GUARDRAIL

SUBJECT: Guardrail Terminals

SUBJECT: Guardrail End Terminals

GUARDRAIL END TERMINALS

Figure C

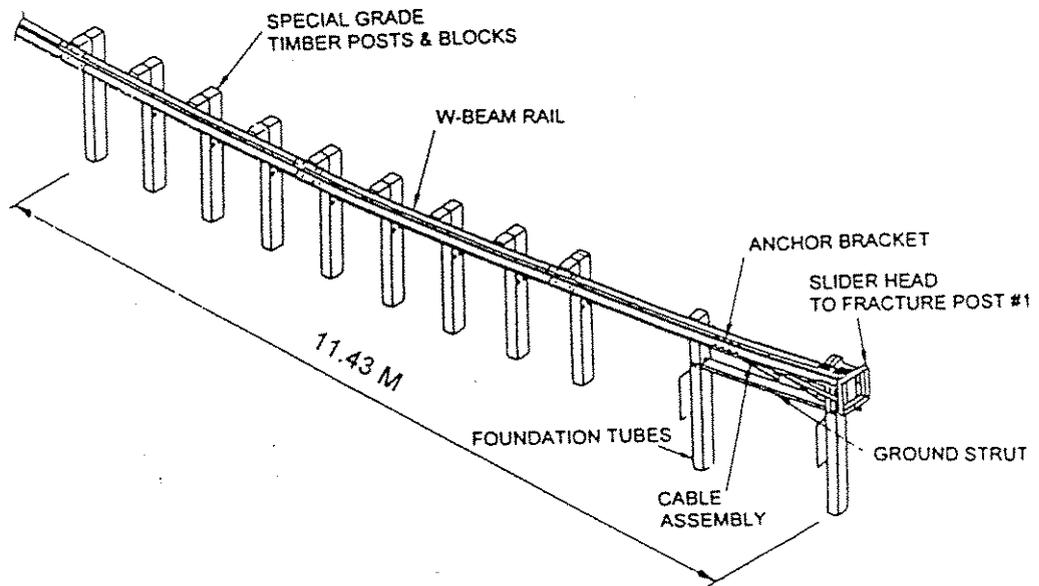
A new flared terminal has been added to the QPL.

- **REGENT**

Type: Parabolic flare, width 1.22 m

Length: 11.43 m

Posts: 10

Energy absorption: Rail buckles

See Figure C, attached

Figure A

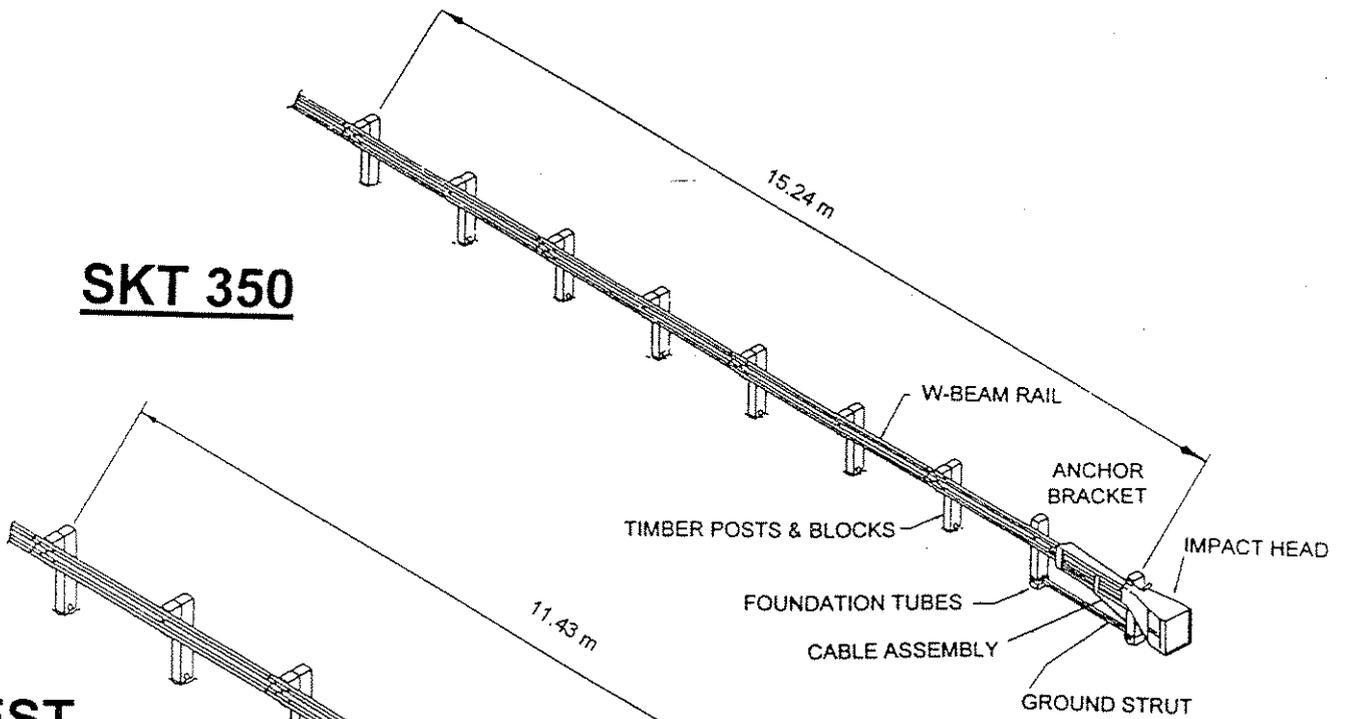
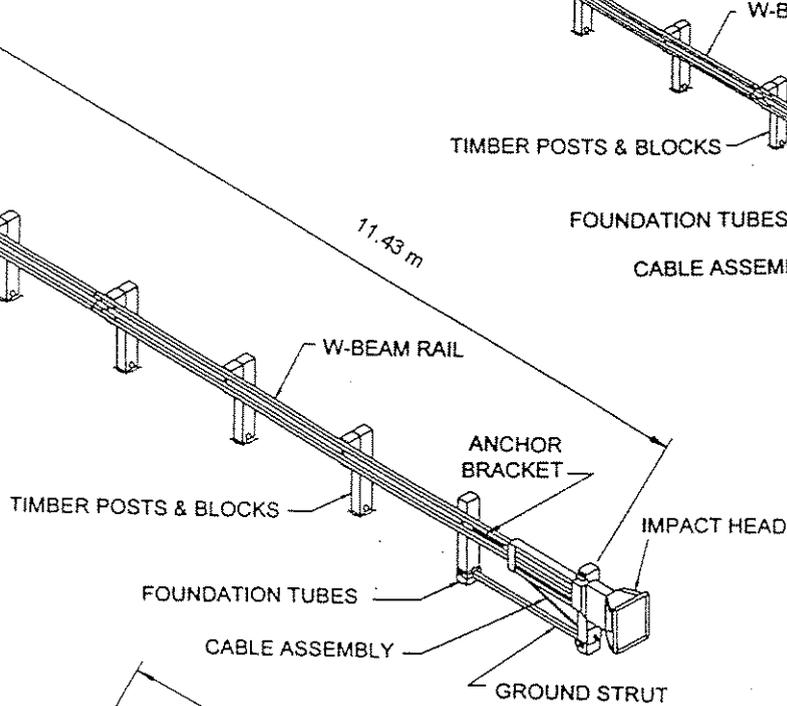
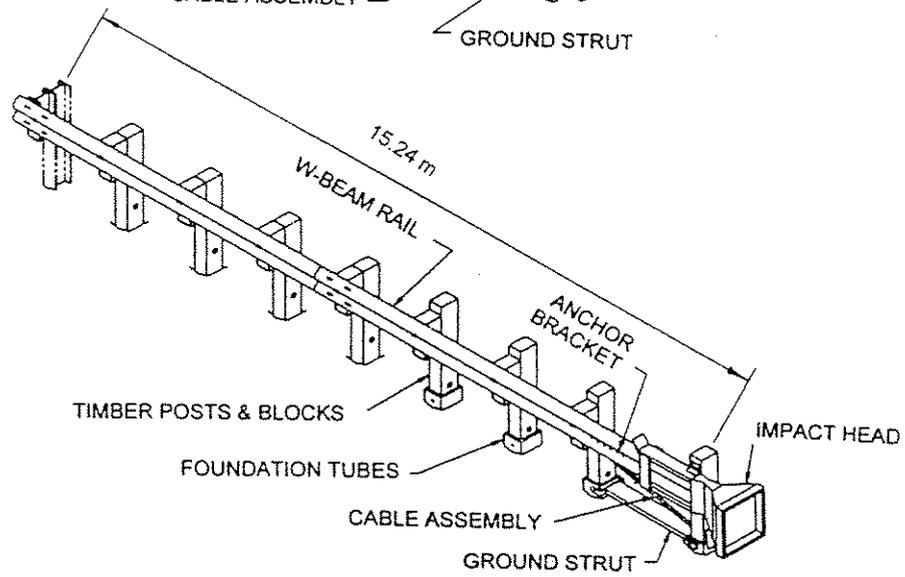
Approved end terminals are shown on Figures A & B and are described as follows:

- **SKT-350**
Type: non-flared
Length: 15.24 m
Posts: 8
Energy absorption: Extruder head kinks rail element

- **ET-2000**
Type: non-flared
Length: 15.24 m
Posts: 8
Energy absorption: Extruder head flattens rail element

- **LET**
Type: non-flared
Length: 11.43 m
Posts: 7
Energy absorption: Extruder head flattens rail element

- **BEST**
Type: non-flared
Length: 11.43 m
Posts: 7
Energy absorption: Head cuts rail element

FLARED TERMINALS

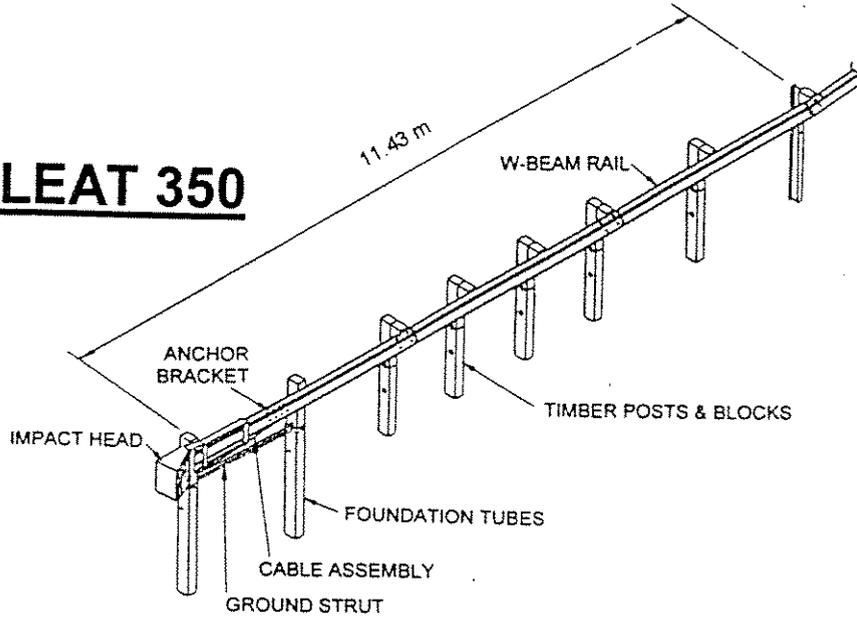
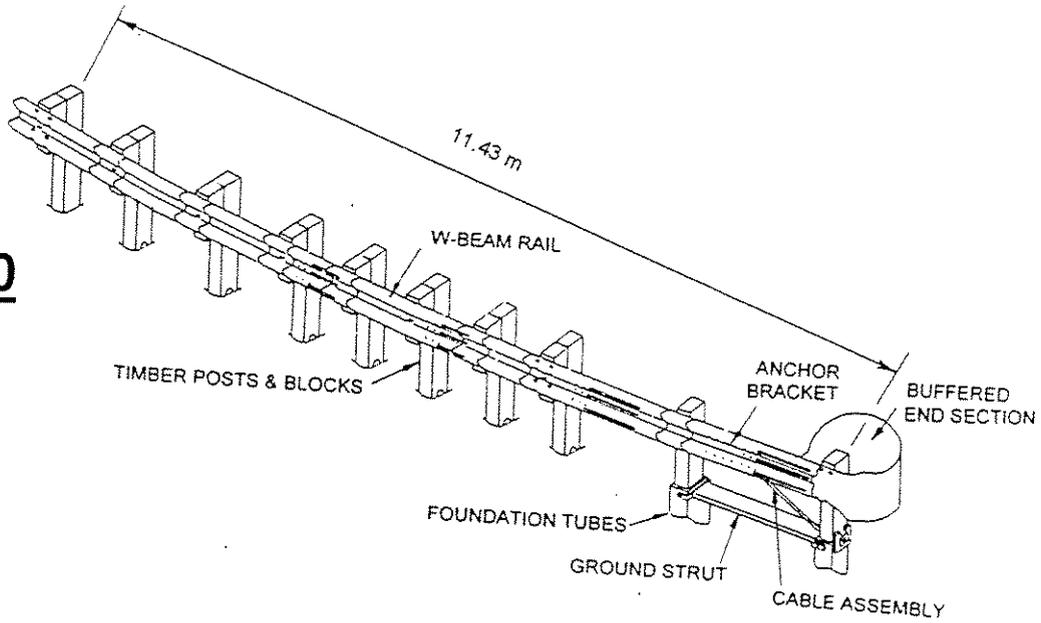
- **FLEAT**

Type: Straight flare, width variable 0.76 m – 1.22 m

- **SRT-350**

Type: Parabolic flare, width 1.22 m

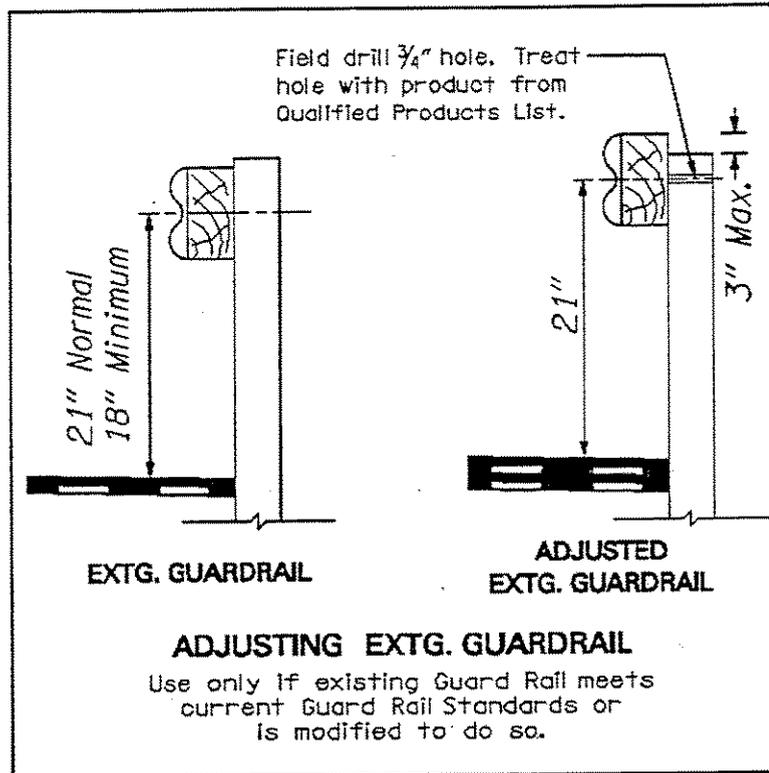
The State of Maryland has received approval from FHWA for a procedure to adjust existing guardrail installations. The detail below shows an acceptable method for raising existing guardrail after pavement overlays. Note that some existing guardrail posts may need to be raised and/or replaced prior to adjusting the rail. This should be noted on the plans and a method of payment for this work should be included in the contract.

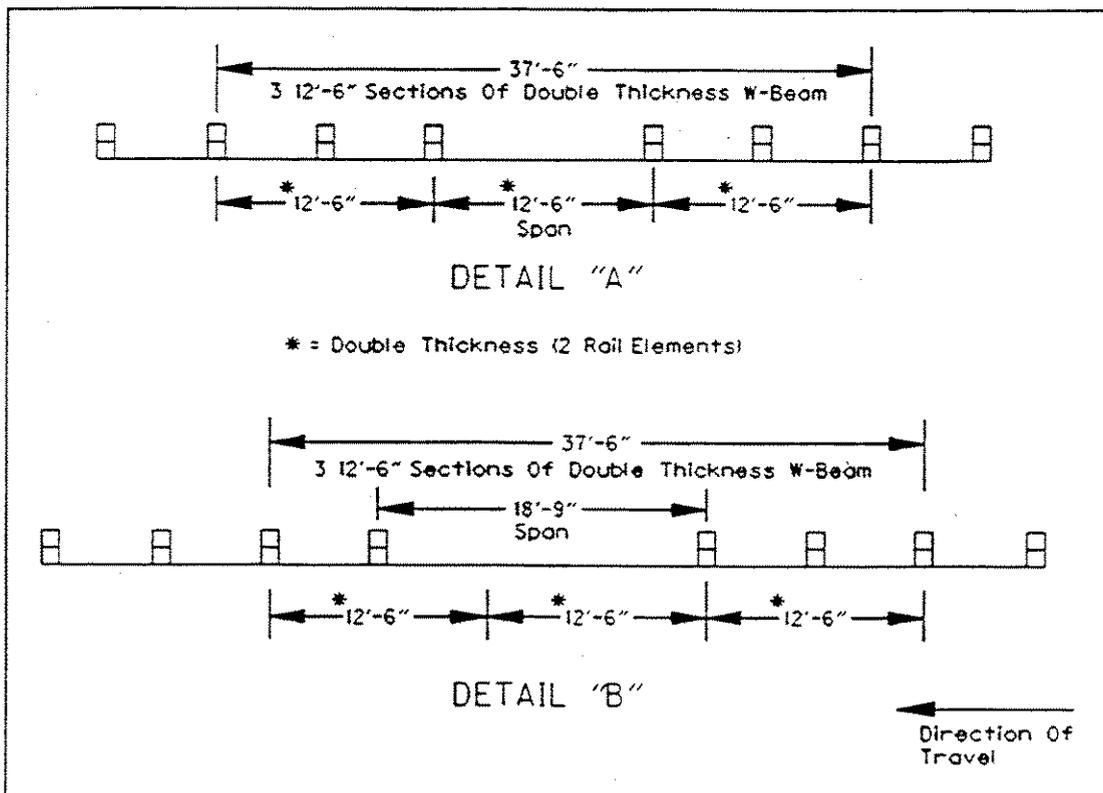
FHWA has recently approved a Washington DOT design proposal for continuing guardrail across a low-fill culvert or other obstruction. Detail 'A', shown below, is an acceptable method for continuing guardrail over areas where a 12'-6" guardrail span, that contains no posts, is necessary. Detail 'B', shown below, is an acceptable method for continuing guardrail over areas where a 18'-9" guardrail span, that contains no posts, is necessary. Contact the Standards Engineer for additional information.

GUARD RAIL INSTALLATION DETAIL

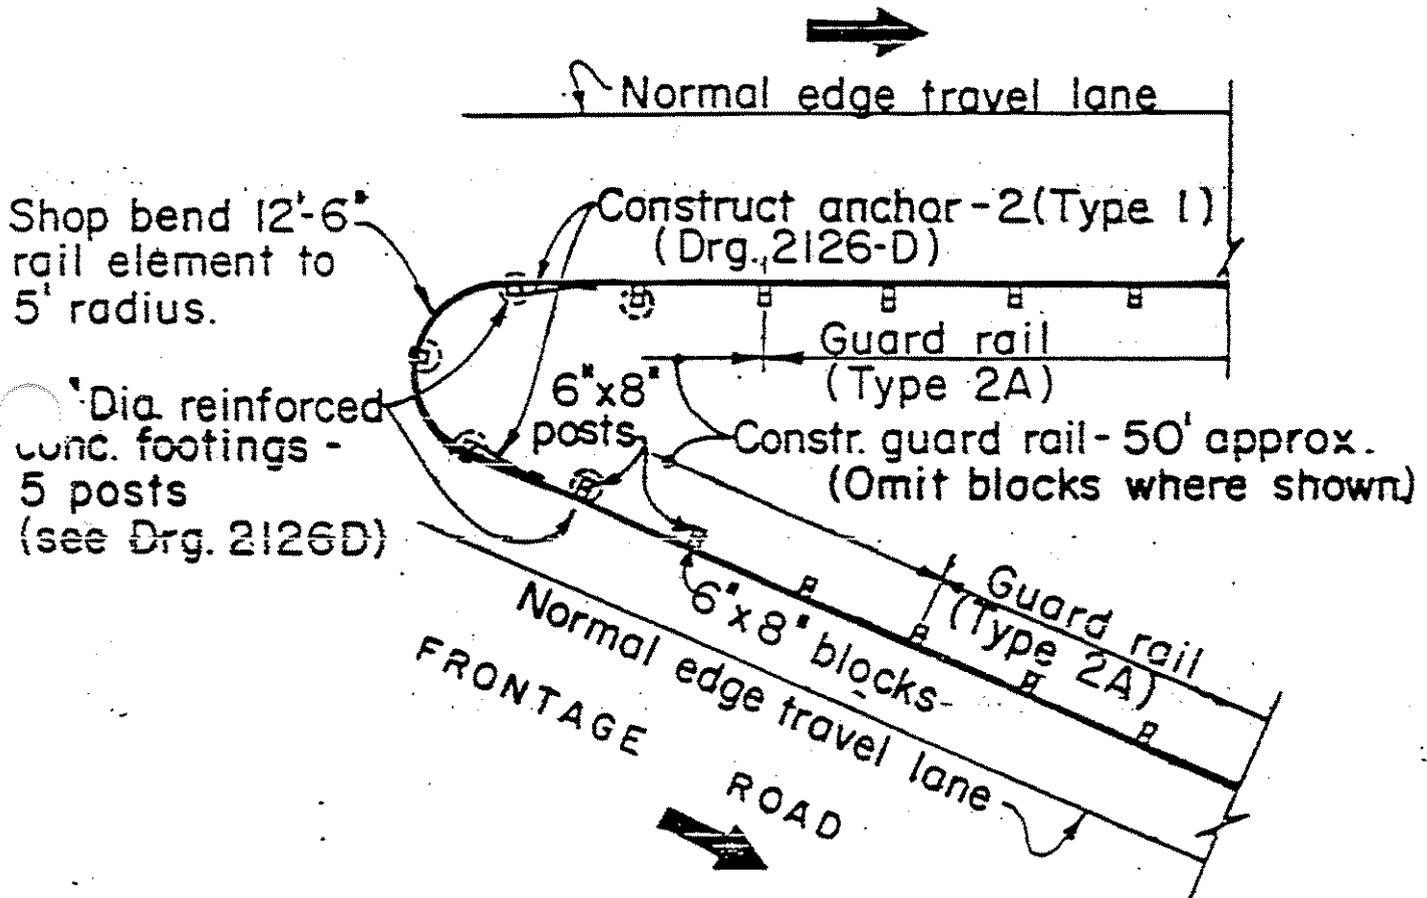
The attached revised detail replaces the existing, distributed to you July 19, 1984.

The revision adds blocks to the last two posts with concrete anchors. The three posts constituting the "bullnose" itself are to remain unblocked.

The purpose of the blocks is to reduce the possibility of snagging an errant vehicle which impacts the rail past the "bullnose" feature.
